**ITEM FOR ENVIRONMENTAL BOARD AGENDA**

**PROJECT NAME:** Woodlawn Baptist Church

**SITE PLAN:** SP-2010-0158C

**SUBJECT:** Woodlawn Baptist Church  
SP-2010-0158C

Exhibit #2

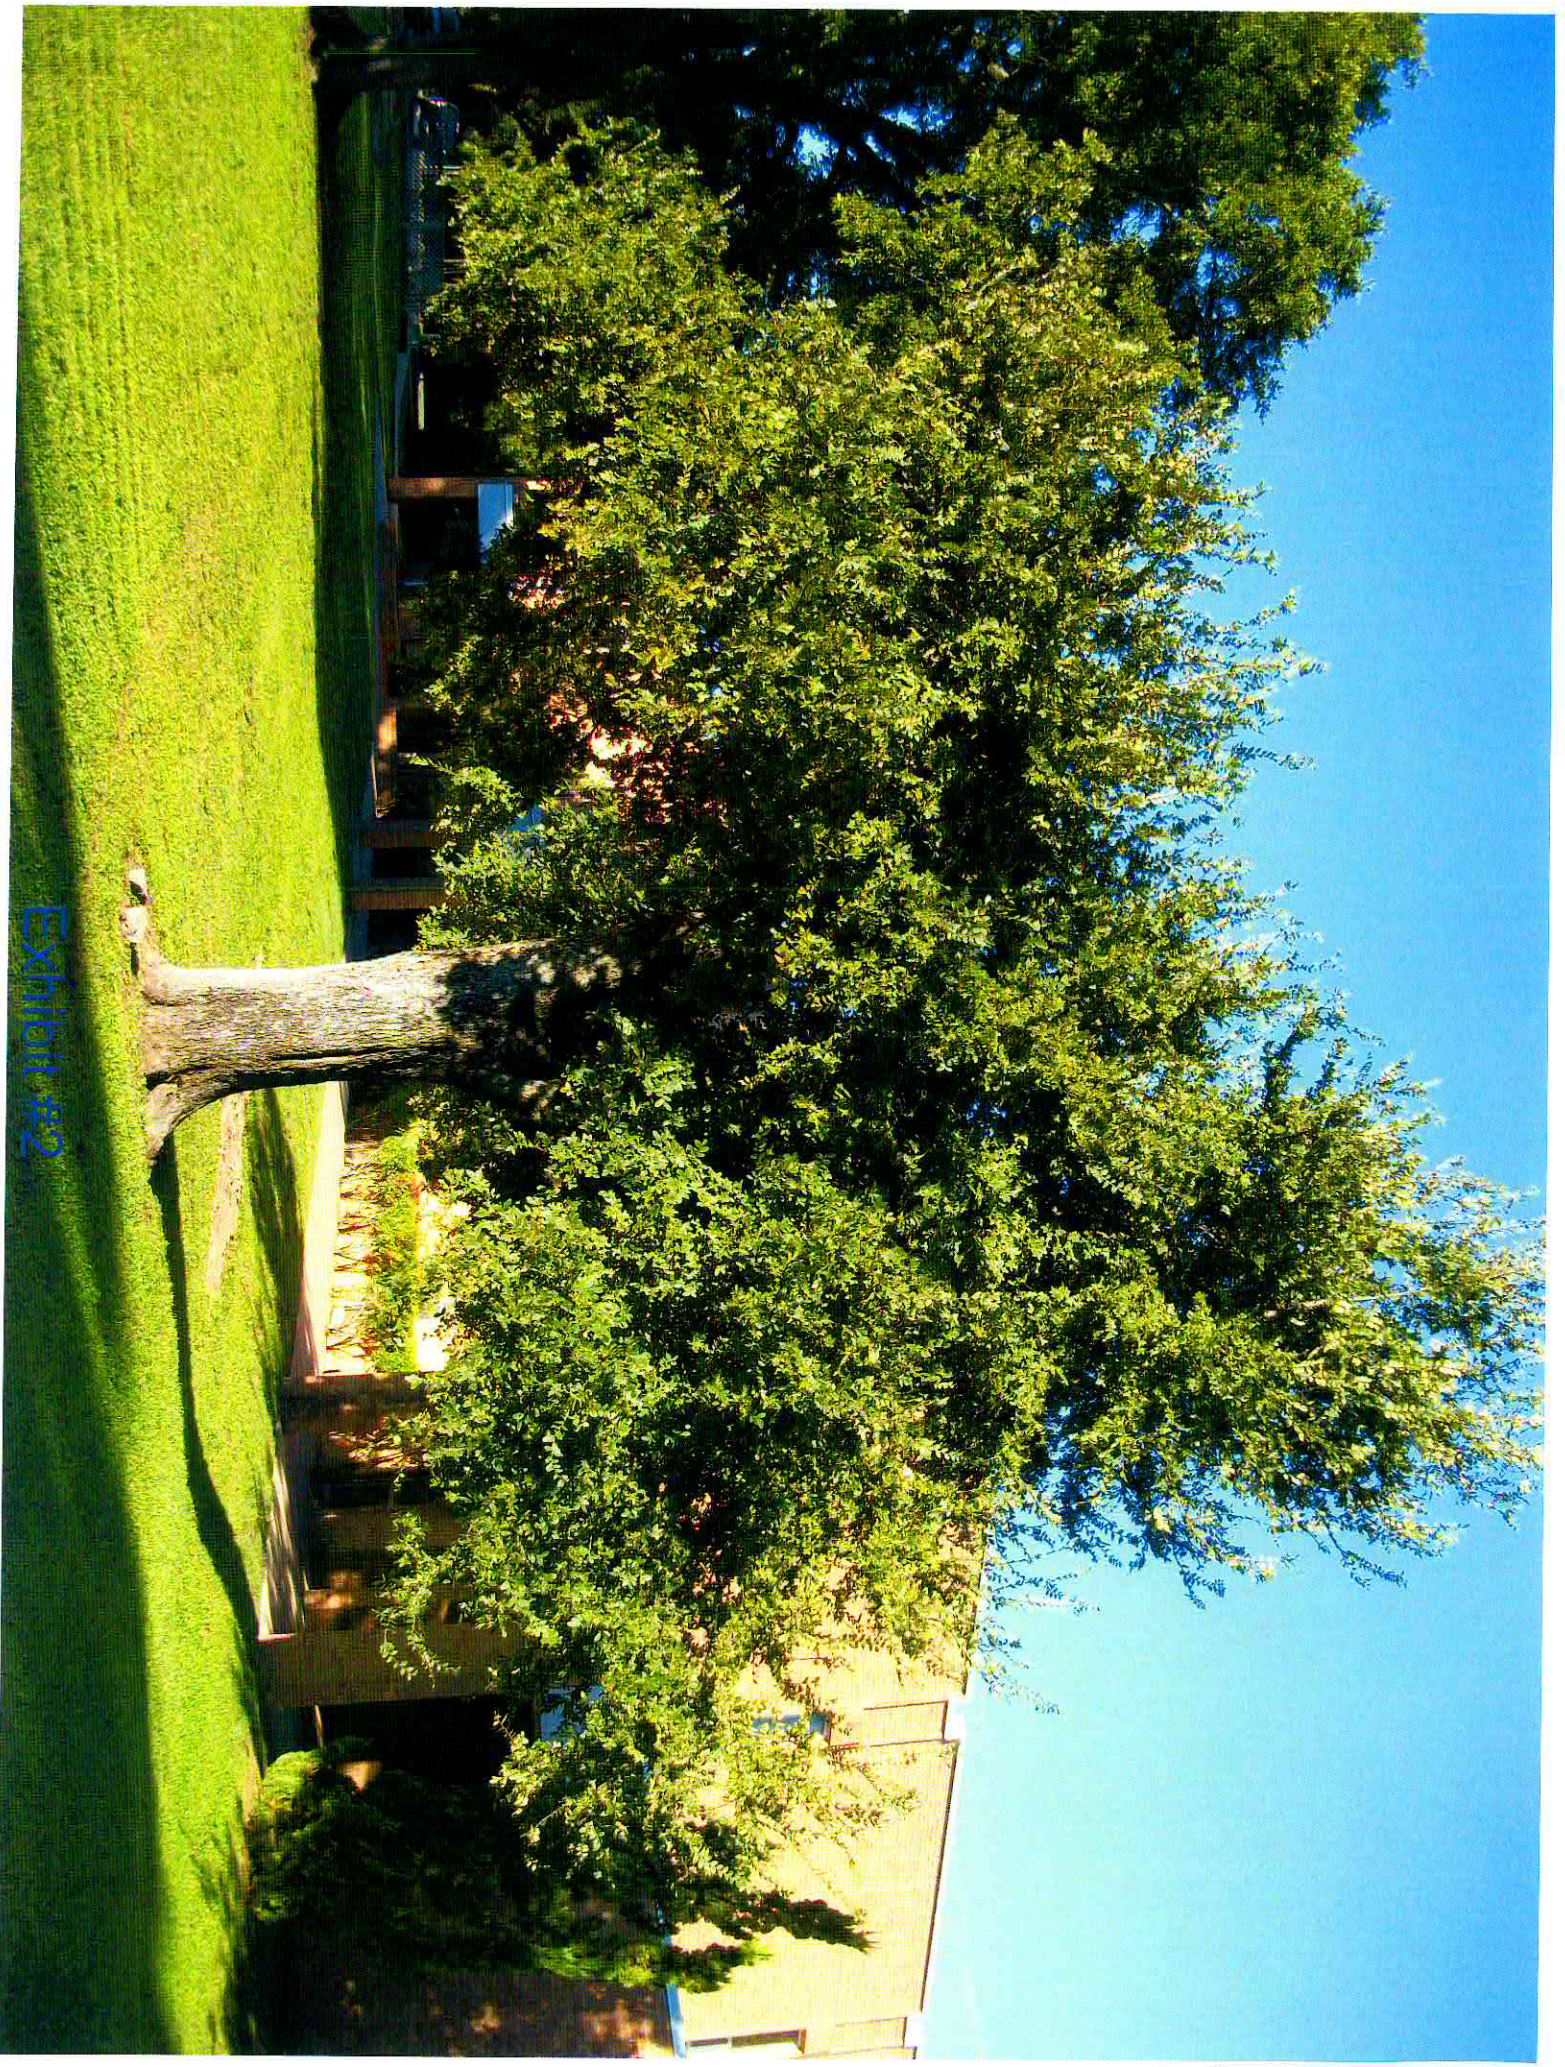
Based on a September 28, 2010, tree assessment, the 27" Cedar Elm displays severe structural defects. The main leader of the subject tree is no longer present (Exhibit 2). This defect is likely due to either storm damage or improper pruning. Further, at some point in the past the subject tree likely had two stems, possibly codominate. One of the stems is no longer present (Exhibit 3). This defect is also likely due to either storm damage or improper pruning. The absence of a main leader has resulted in lateral bud growth and an imbalanced canopy (Exhibit 4). This has further exacerbated the structural weakness of the tree already weakened by decay and poorly attached adventitious stems (Exhibit 5).

Exhibit #6

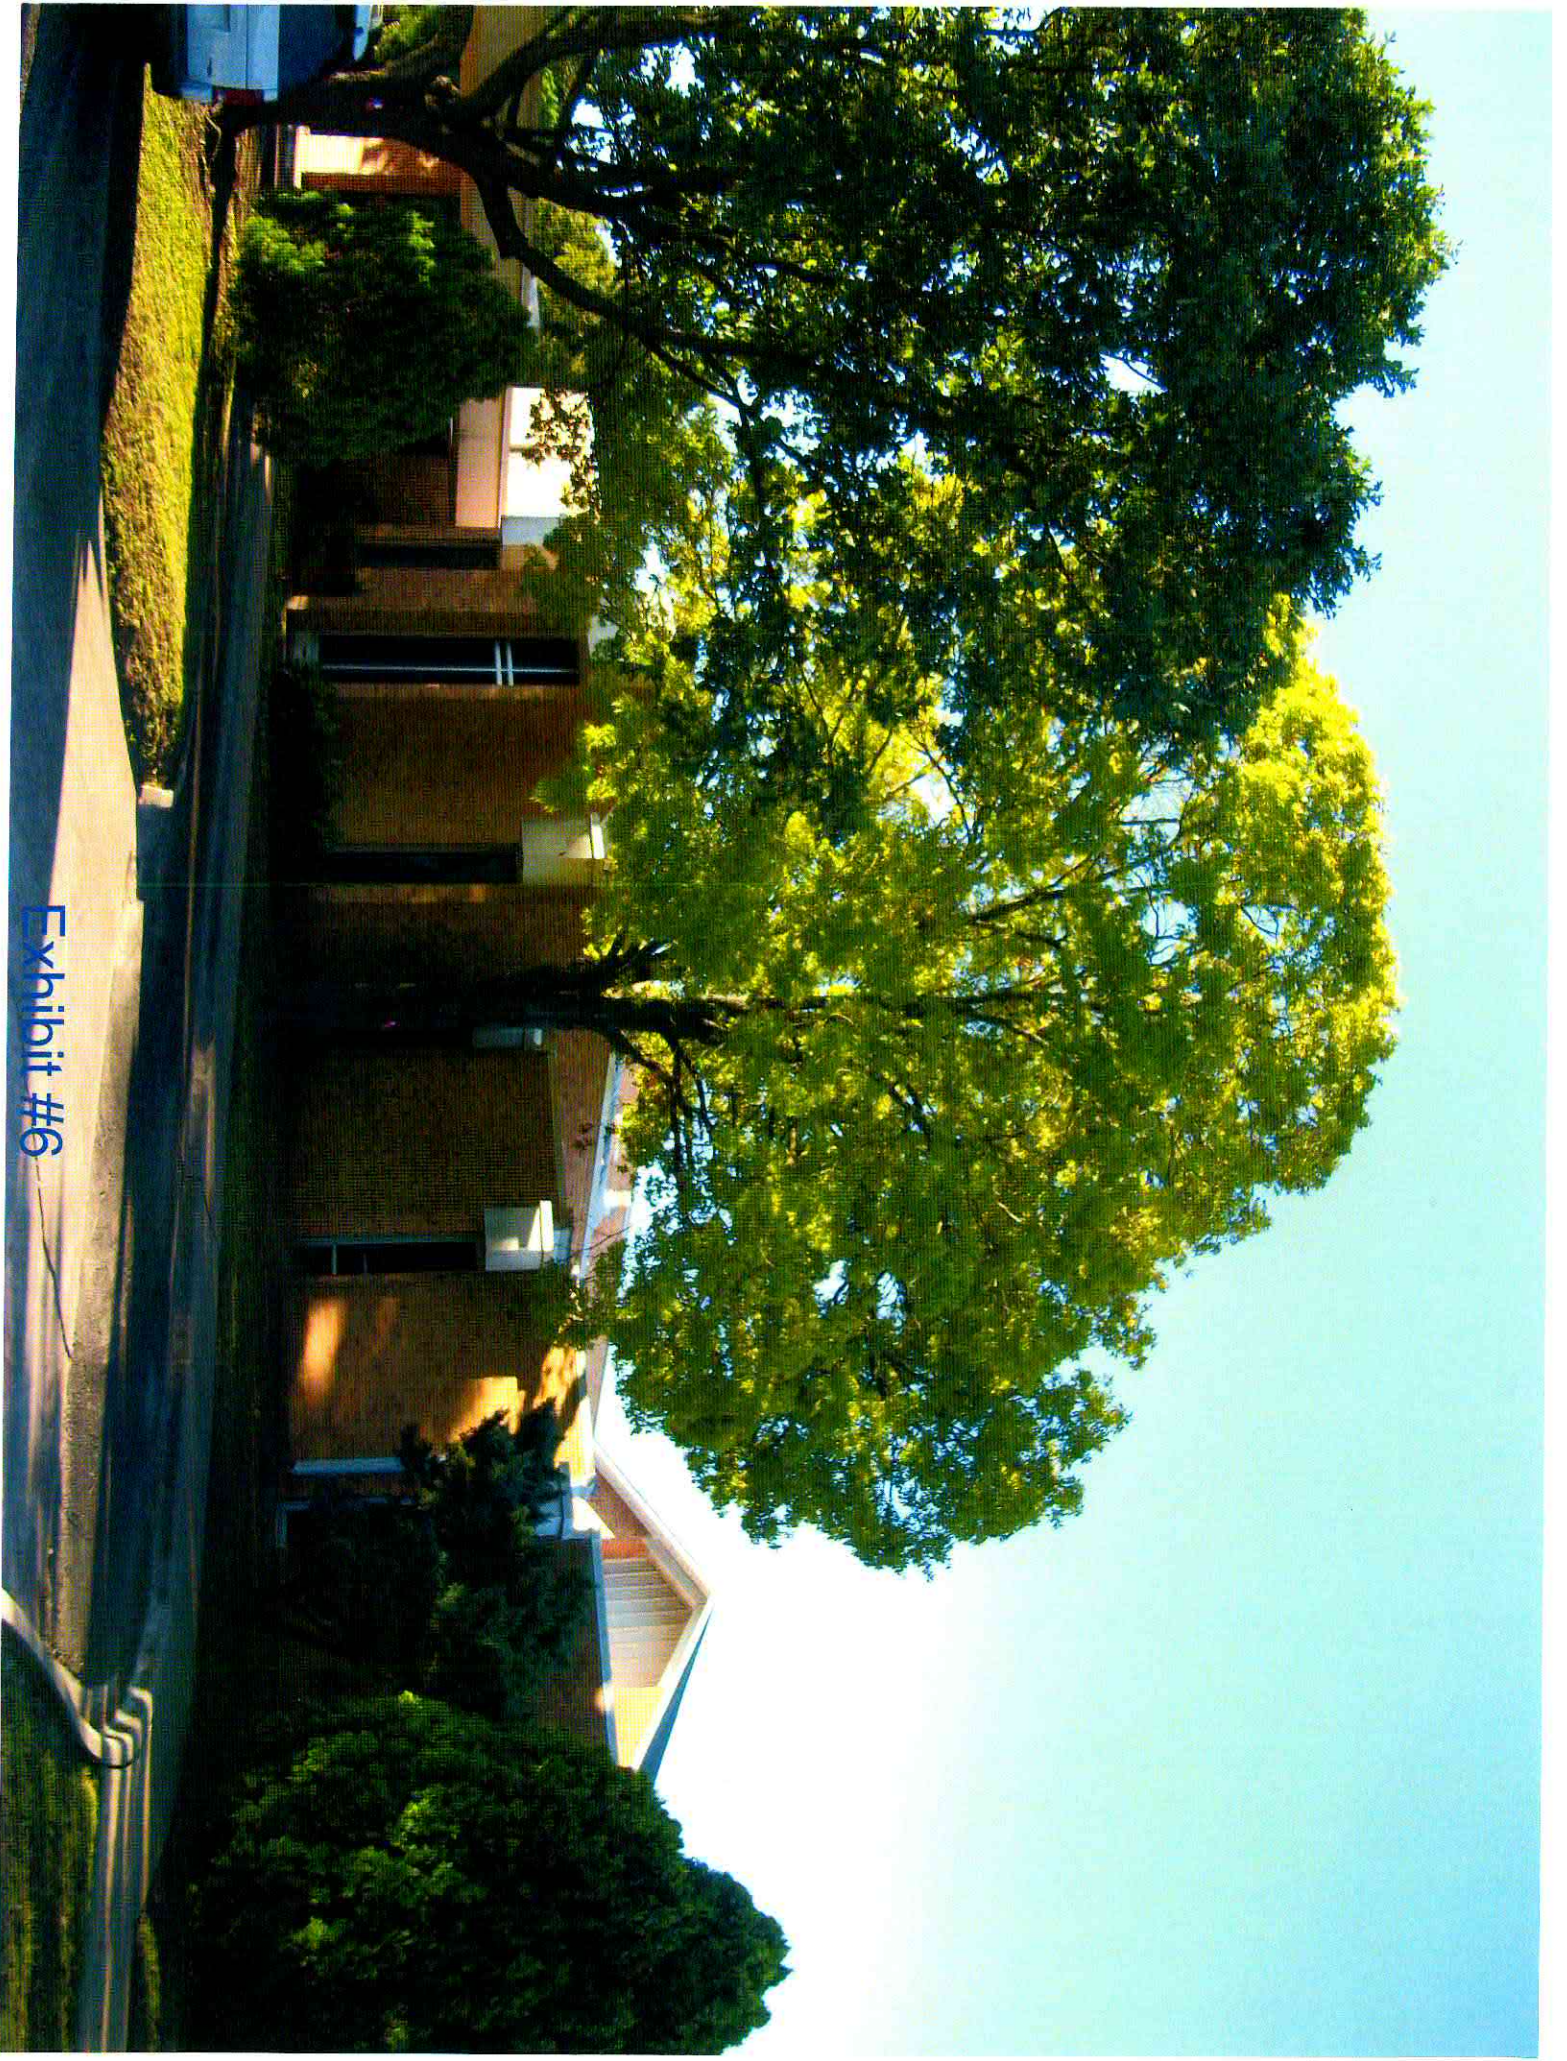
Based on a September 28, 2010, tree assessment the 24" Red Oak (*Quercus* spp.) was identified as a Red Oak displaying severe symptoms of foliar chlorosis (Exhibit 6). This tree has likely suffered from chronic chlorosis due in part to soil compaction (Exhibit 7) and calcareous soils, but more so from a poor choice in species selection as this species or cultivar of Red Oak does not appear to be a native species based on analysis of the leaf morphology. The subject tree appears to be either (1) a cultivar of *Quercus shumardii* or (2) a species of red oak from the southeastern United States. Either way, the tree species is likely adapted to more acidic soils than the existing soil conditions.
